**Re: Oak Street Condominiums, Lot 10, Block 22, Brownell & Lail's Addition  
Drainage Report - Engineer's Stamp dated 3-31-05 (K15-D82)**

**DRAINAGE INFORMATION SHEET**  
(REV. 1/28/2003rd)

RE: OAK STREET CONDOMINIUMS (K15 / D82)

DRAINAGE REPORT  
FOR

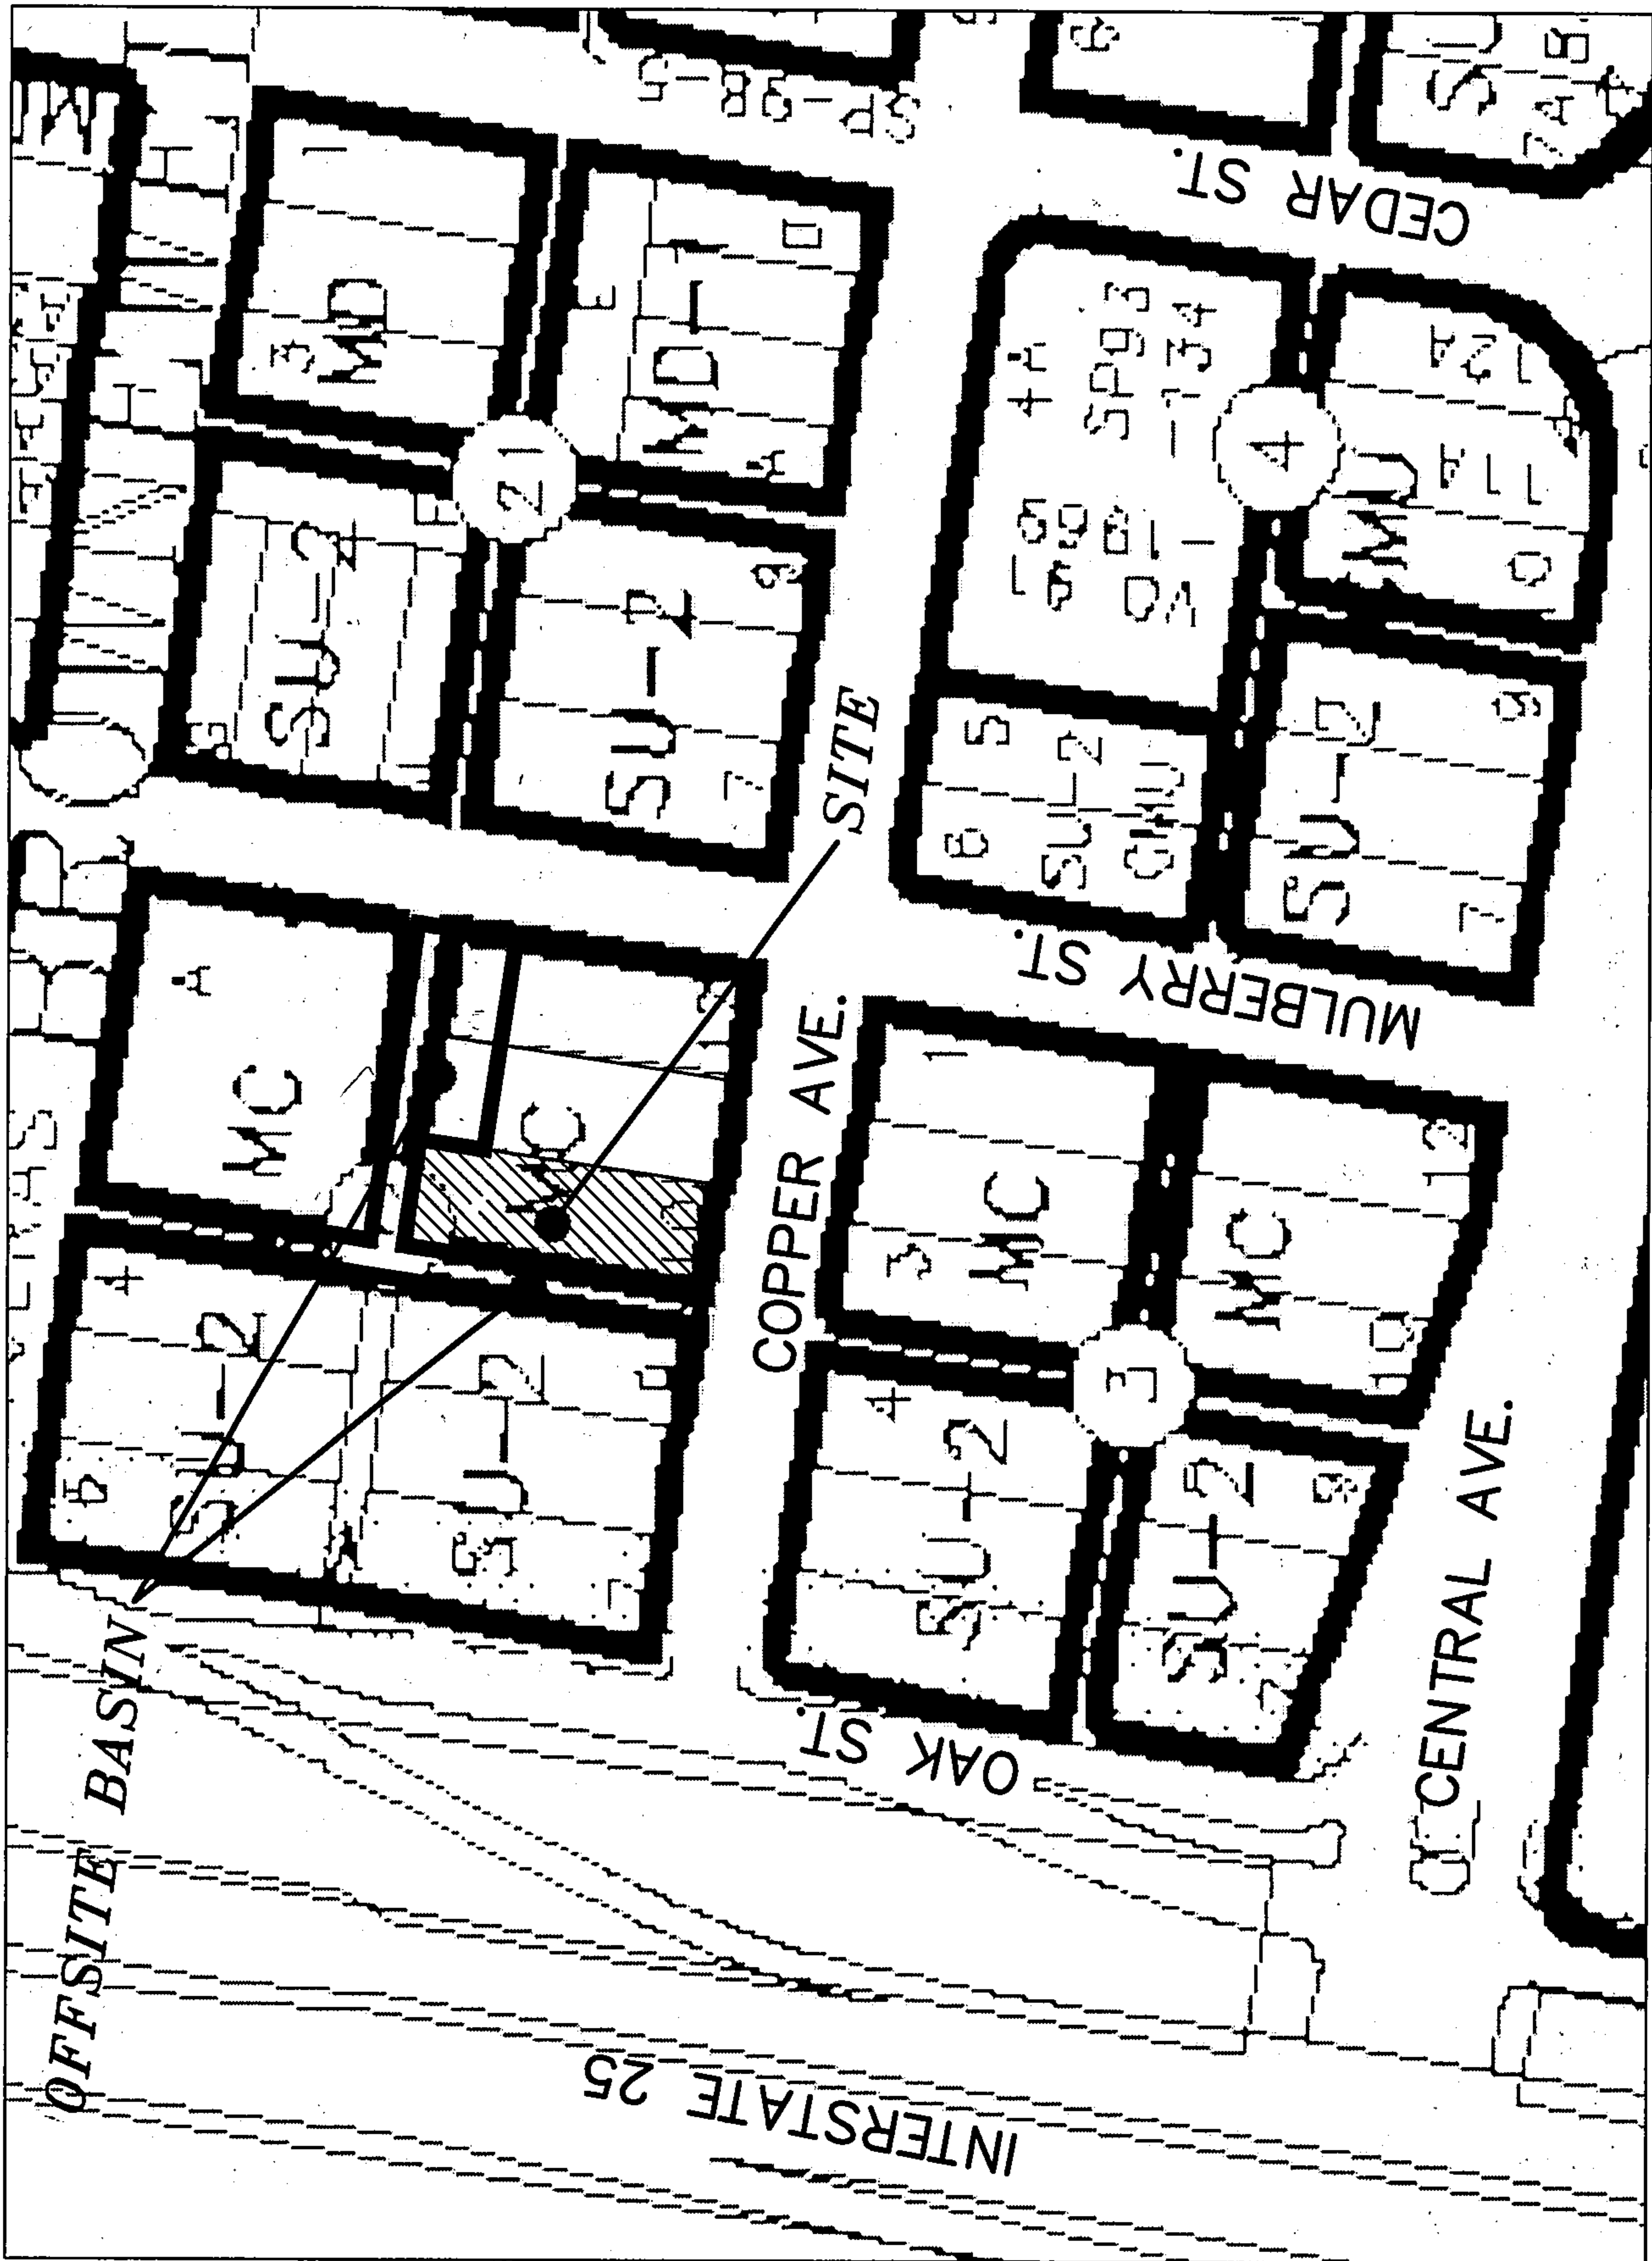
- ✓ • Provide details or reference COA Standard drawings for storm inlets, sidewalk culvert and trench drain.
- ✓ • Provide a detail for the backyard wall openings and designate each location where required on plan.
- ✓ • Add note stating that the alley improvements are to be done through C.O.A Work Order process.
- ✎ • Proposed 2' Roadway Easement needs to be recorded.

City Standard Drawing numbers are called out on the plan for the storm sewer inlets, and the sidewalk culvert. A trench detail is added to the plans (trench system TF-14).

We have added a note that 3 CMU blocks to be turned at the wall for drainage. Location of all the wall openings are added to the revised grading plan.

A note is added to the grading plan that the Alley construction work has to be done through C.O.A. Work Order process.

The easement has been changed to a 4' easement. We are in the process of preparing the easement. As soon as the easement is finalized and recorded we will forward you a copy.
